3 ARNHILL ROAD GRETTON NN17 3DN	
PROPOSED CROSSOVER AND OFF ROAD PARKING	SCALE
Dimensions in mm DO NOT SCALE - Builder to verify site measurements before ordering materials, fabrication and construction	1:100
Drawing for statutory approvals only	08 C

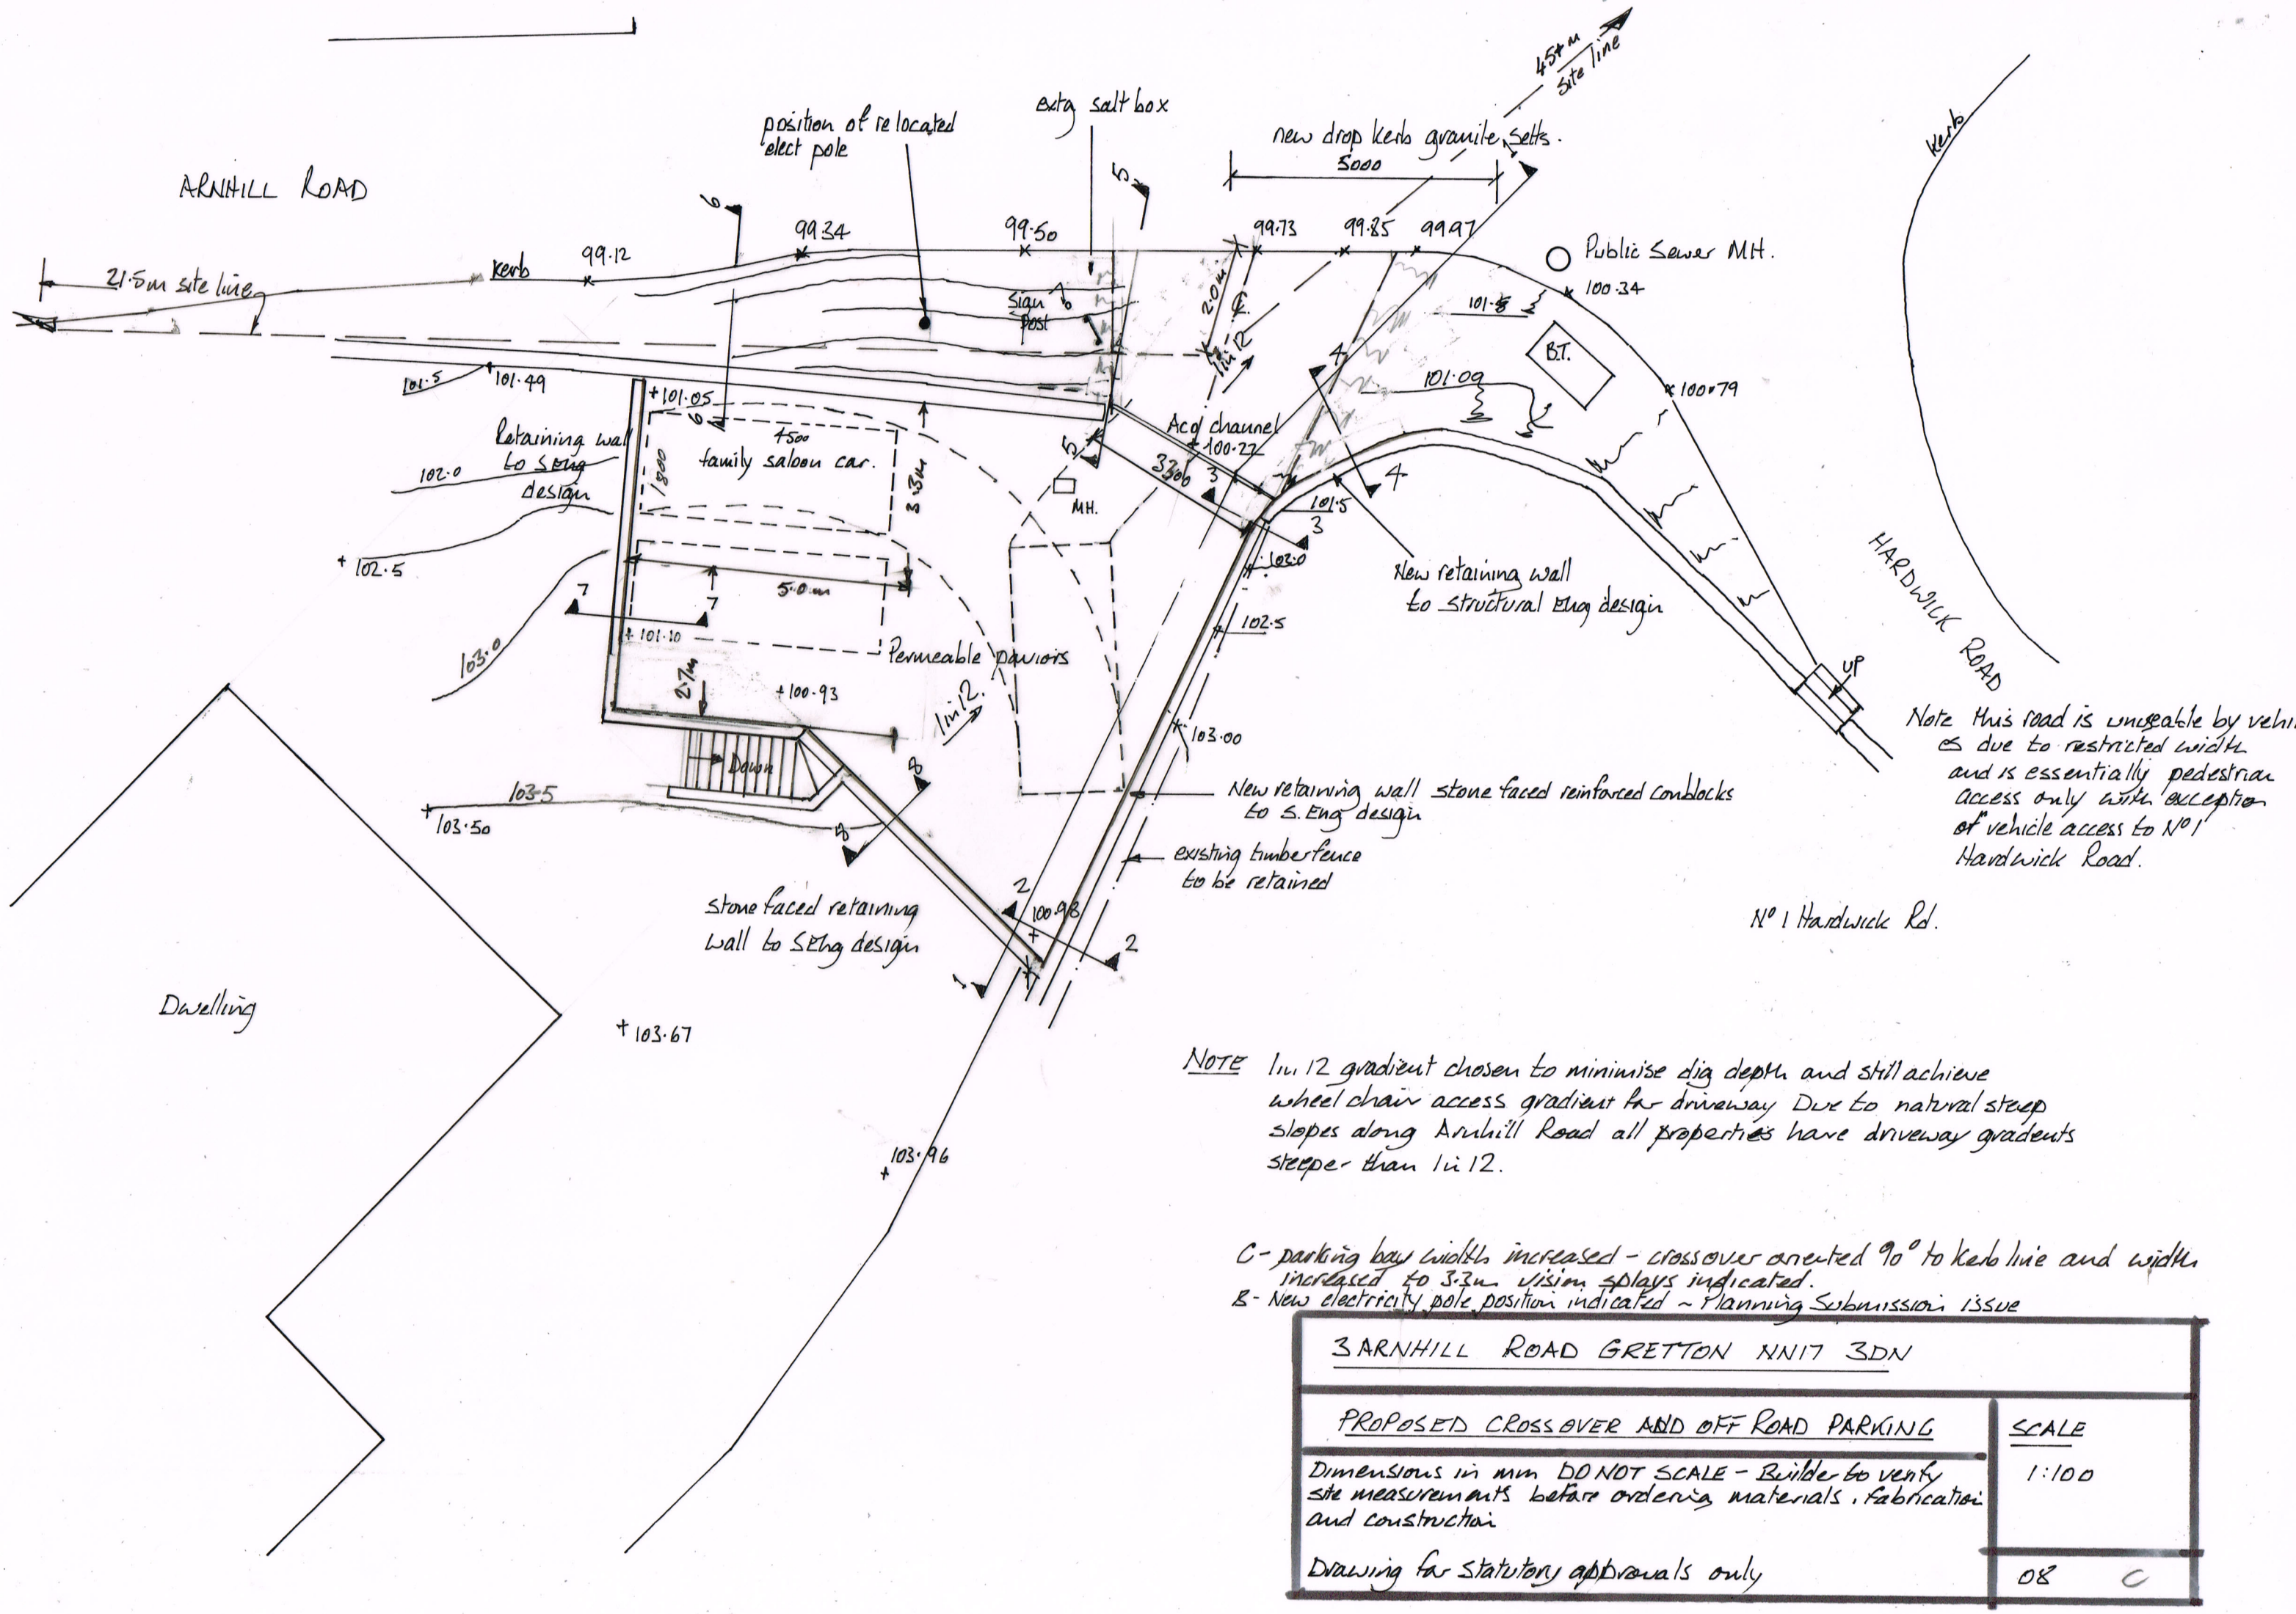
C - parking bay width increased - crossover oriented 90° to kerb line and width increased to 3·3m vision splays indicated.
B - New electricity pole position indicated ~ Planning Submission issue
